SUBJECT: PALO VERDE NUCLEAR GENERATING STATION, UNIT 3 - SUMMARY OF
CONFERENCE CALL REGARDING 2006 STEAM GENERATOR TUBE
INSPECTION RESULTS (TAC NO. MD1240)

SUMMARY OF CONFERENCE CALL

REGARDING 2006 STEAM GENERATOR TUBE INSPECTION RESULTS

Steam Generator Tube Inspection Discussion Points – Briefing Paper

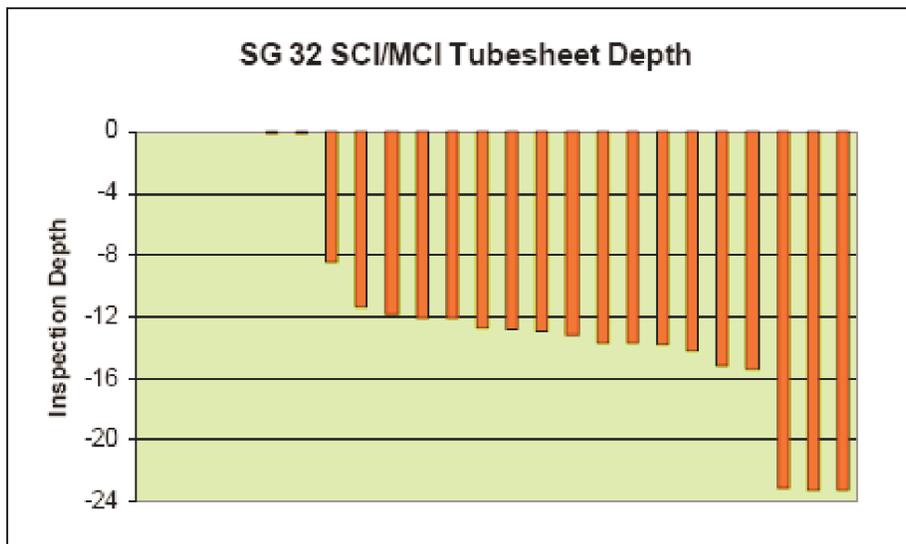
- 7. Discuss the previous history of SG tube inspection results, including any “look backs” performed. Specifically for significant indications or indications where look backs are used in support of disposition (e.g., degradation mode or location of degradation new to this unit).**

Historical “look backs” to be discussed during briefing and in discussion of Item 8 regarding expansions.

With regard to tubesheet inspections, which was the focus of a call between APS and the NRC on March 29, 2006 and RAs with respect to C* criteria – The following update is provided.

As indicated in the 3/29/06 call, additional analysis performed by Westinghouse to accommodate “first slip” resulted in a change to the minimum inspection depth to 12.6 inches below the Bottom of the Expansion Transition (BET). APS indicated an intention to change the minimum inspection depth to 13 inches. For U3R12, the inspection was conducted at a 14 inch depth to provide additional margin. As such, the acquisition and data management personnel verify that at least 14 inches of inspection length below the

BET is acquired. As a figure of merit, the average inspection depth (from TTS) is 15.31 inches in SG 31 and 15.41 inches in SG 32.

As reported previously, in general, tubesheet SCC is not a progressing damage mechanism. That is, most of the defects detected are outside previously inspected elevations. Additionally, in the case of SG 31, no circumferential SCC was found outside the tubesheet transition region. For SG 32, the distribution of circumferential SCC indicates that most of the detected flaws are beyond the inspection depth performed in U3R11 (i.e., 12 inches). See below.
